Agenda
City of Springboro Planning Commission Meeting
Wednesday, October 12, 2022, 6:00 p.m.
Council Chambers, City Building, 320 West Central Avenue

Background Information & Staff Comments
City of Springboro Planning Commission Meeting
Wednesday, October 12, 2022, 6:00 p.m.
Council Chambers, City Building, 320 West Central Avenue

Site Plan Review, 800 West Central Avenue (SR 73), proposed Sheetz fuel center, convenience store/restaurant

SHEET NO.: C-000

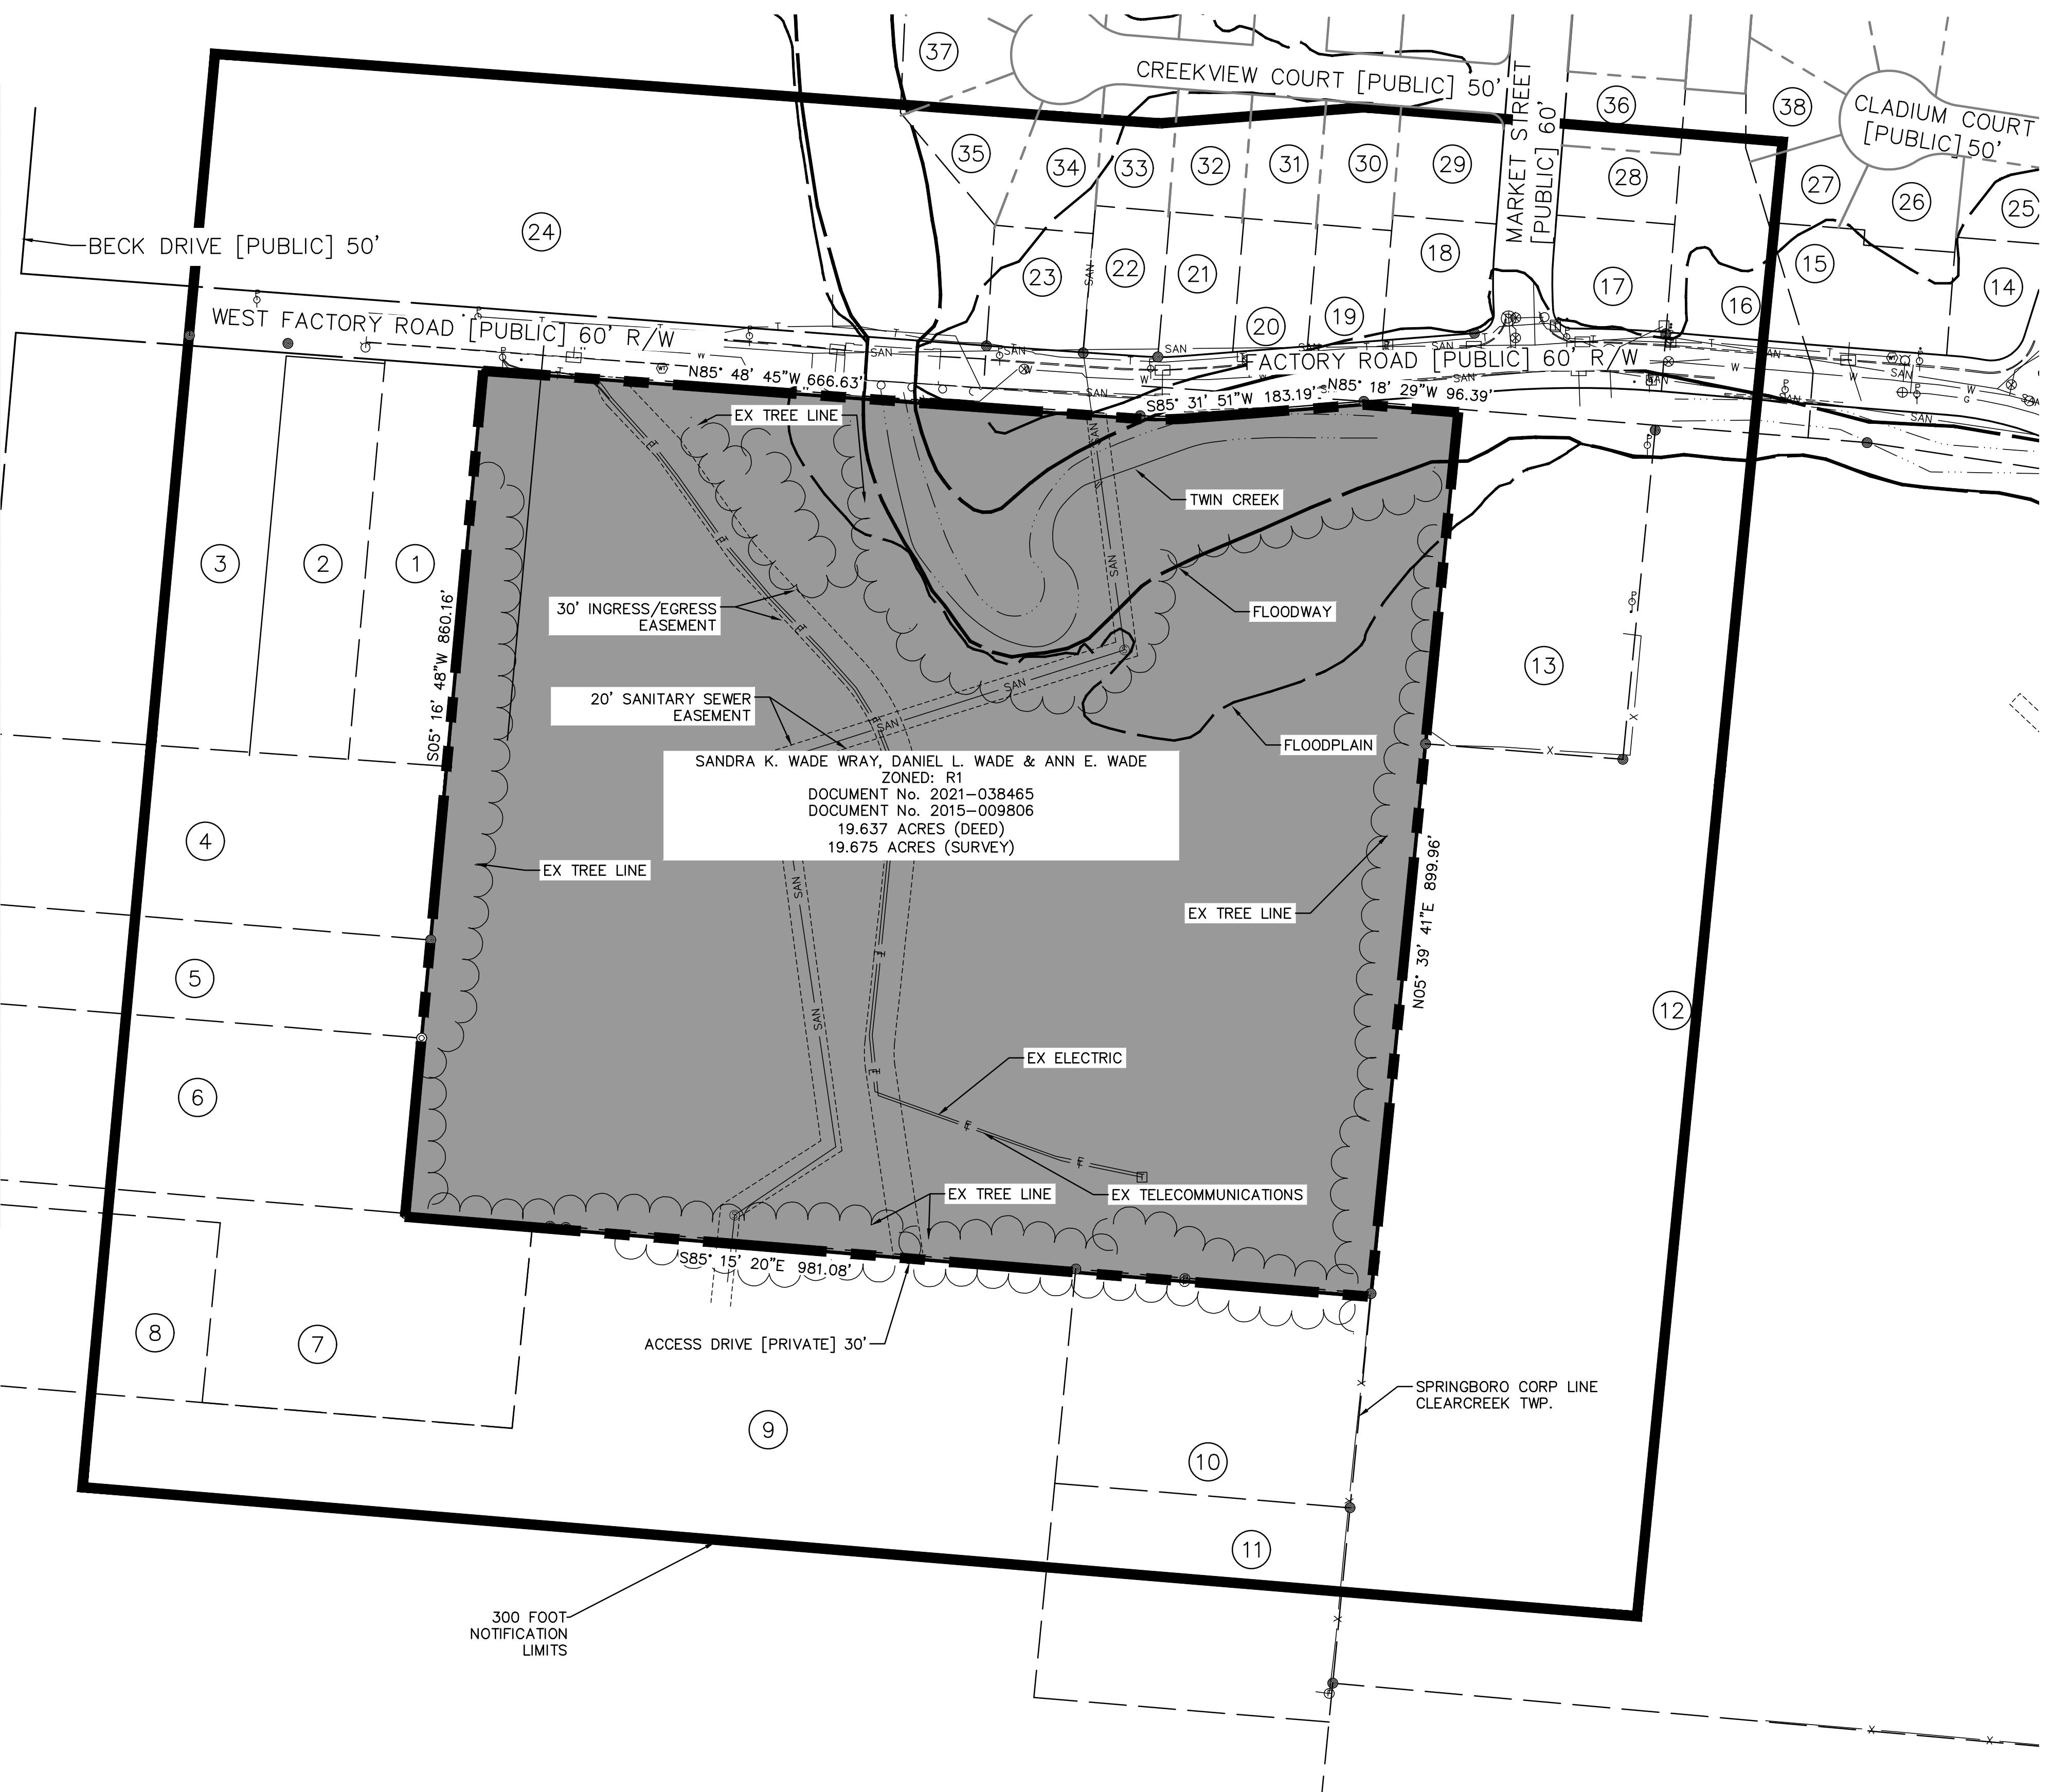
12. Revise title on Sheet C-000 to state General Plan.
13. Provide location of Central Mailbox Unit(s), which are to be reviewed and approved by the Post Master.

SHEET NO.: C-100

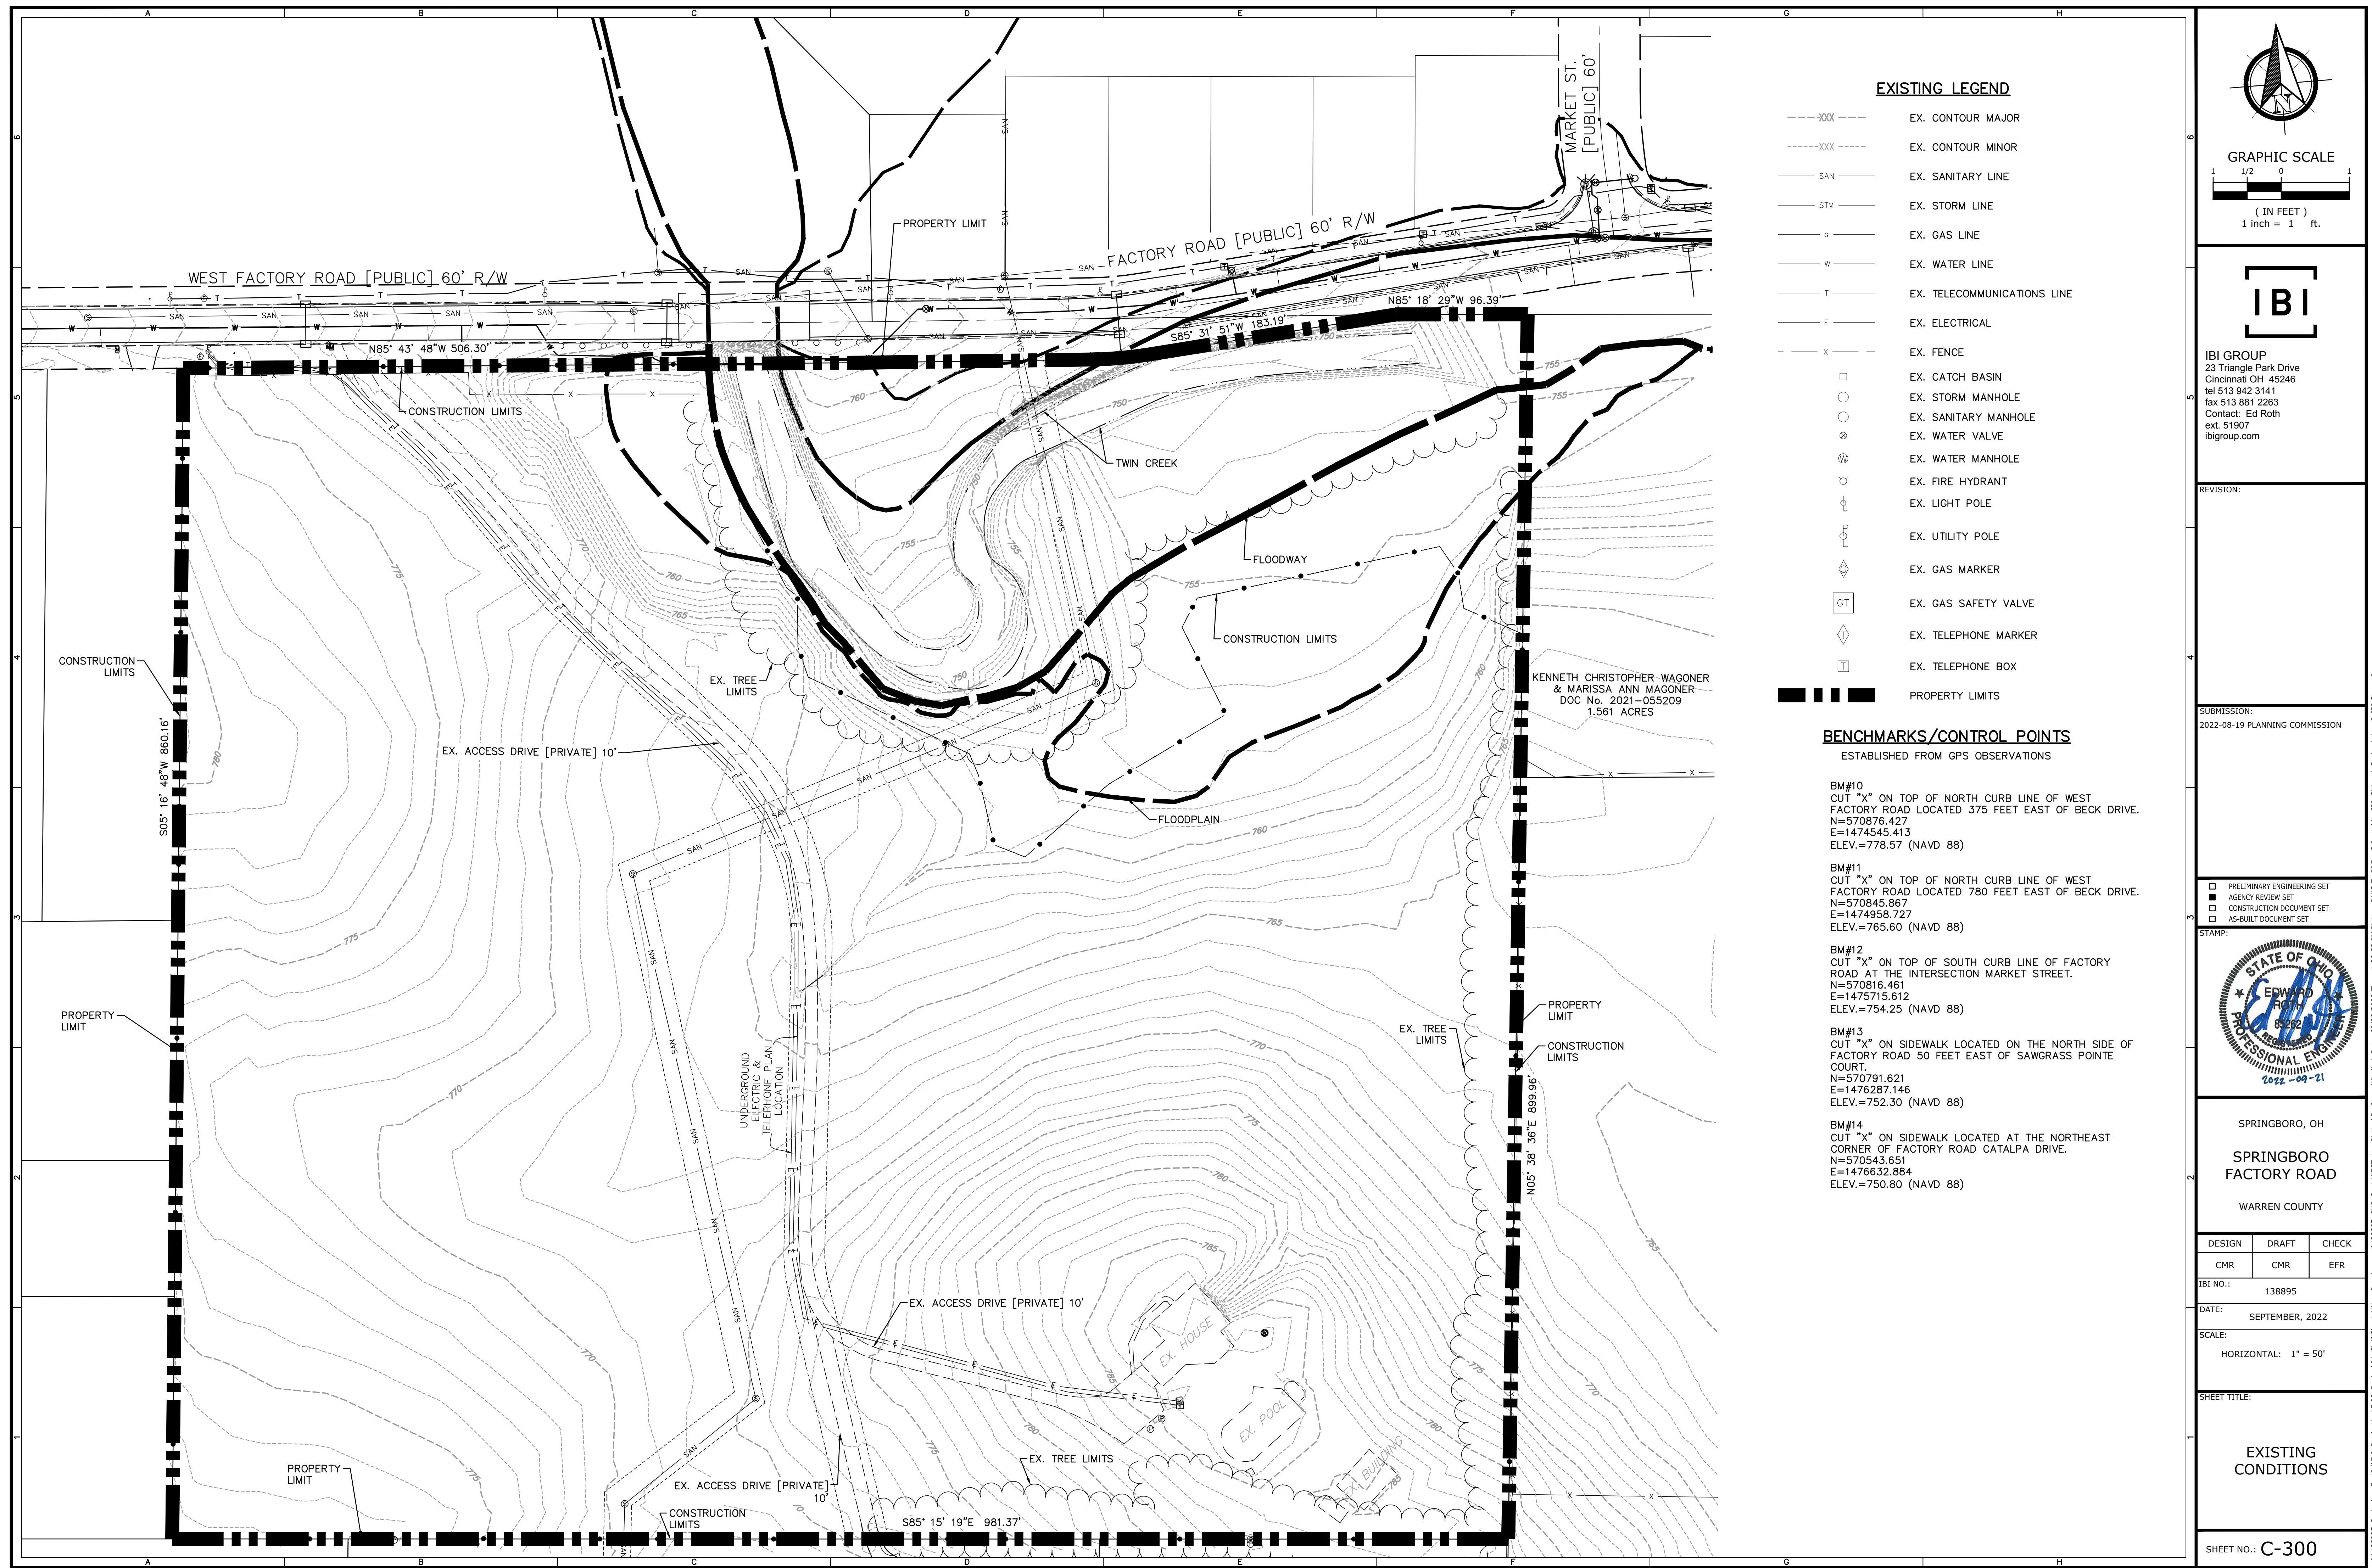
11. Bridge "Proposed Structure" table on sheet C-700 does not match details on sheet C-702.
